12 August 2020

Attention: Cape EAPrac represented by Mr. Dale Holder

Proposed ammendment of Environmental Authorisation for Bloemsmond 3 to include a Battery Energy Storage System (BESS)
Aquatic Specialist Statement

Figure 1. Comparison of the Bloemsmond 3 layout without (a) and with (b) the proposed BESS indicated as the shaded blue area with red arrow.

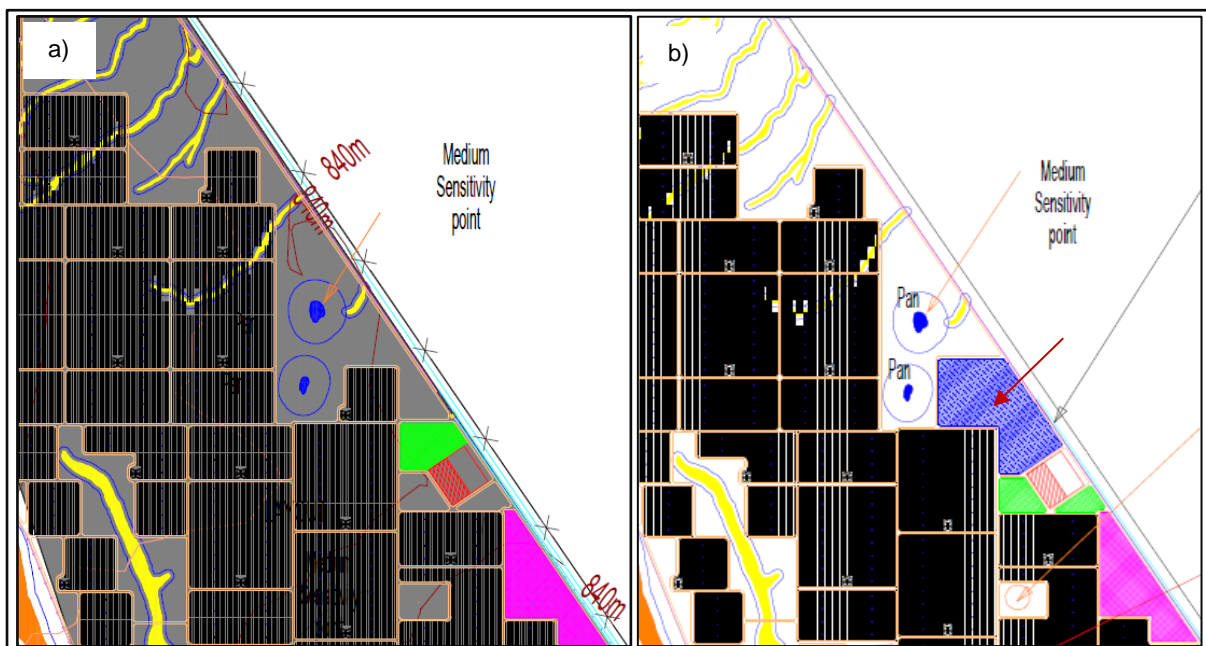
The footprint occupied by the proposed BESS would mostly replace a section of PV panels (black) and infrastructure associated with operations and maintenance

buildings (bright green). Two small pans and an associated drainage line are the only aquatic features located in proximity to the proposed BESS. While the BESS would be marginally closer to these aquatic features, the actual footprint and location is not considered to be much greater than what was previously proposed. Furthermore, the BESS does not encroach on any of the buffers stipulated for the pans and drainage line (indicated in Figure 1).
